Access Compliance Report

Public Rights-of-Way

(Curb Ramps)

Intersection ID: 43659	Main Street: TAYLOR RIDGE LN	Cross Street: STARR NEELY RD	Location: NW
ADA ID: 35DE496C3930	Ramp Type: Perp	Initial Pass/Fail: Fail	Overall Compliance: No
Severity Score: 21.25			
Codes/Mitigation Info/Possible Solution		Field Measurements/Component Compliance

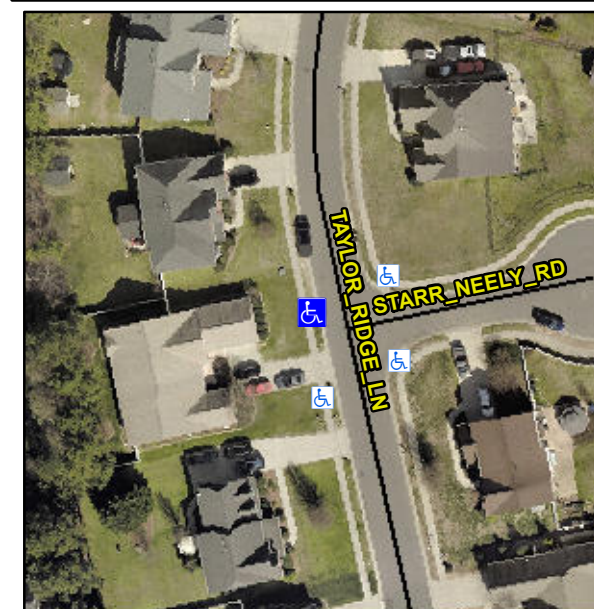
Not Found, R304.5.1, R304.2.2

Compliance	Description	Data	Compliance	Description	Data
N/A	Ramp Length (in)	46.0	No	Ramp Slope (%)	10.1
No	Ramp Width (in)	46.0	Yes	Ramp XSlope (%)	1.5
N/A	Flare Type LT	N/A	N/A	Flare Type RT	N/A
N/A	Flare Slope LT (%)	N/A	N/A	Flare Slope RT (%)	N/A
N/A	Flare Traversable LT?	N/A	N/A	Flare Traversable RT?	N/A
N/A	Landing Length (in)	N/A	N/A	DWS Provided?	N/A
N/A	Landing Width (in)	N/A	N/A	DWS Contrast?	N/A
N/A	Landing Slope (%)	N/A	N/A	DWS Length (in)	N/A
N/A	Landing X Slope (%)	N/A	N/A	DWS Full Width?	N/A
N/A	Landing Curb? (Y/N)	N/A	N/A	DWS Offset (in)	N/A
N/A	Shared Landing?	N/A			
N/A	Gutter Ponding?	N/A	N/A	Gutter Slope (%)	N/A
N/A	Gutter Lip Ht (in)	N/A	N/A	Gutter X Slope (%)	N/A
N/A	Painted X Walk1?	No	N/A	Painted X Walk2?	N/A
	X Walk 1 Direction	To E		X Walk 2 Direction	N/A
N/A	X Walk 1 Width (in)	N/A	N/A	X Walk 2 Width (in)	N/A
	X Walk 1 Slope (%)	1.9		X Walk 2 Slope (%)	N/A
	X Walk 1 X Slope (%)	0.6		X Walk 2 X Slope (%)	N/A

Remove & Replace Entire Ramp.
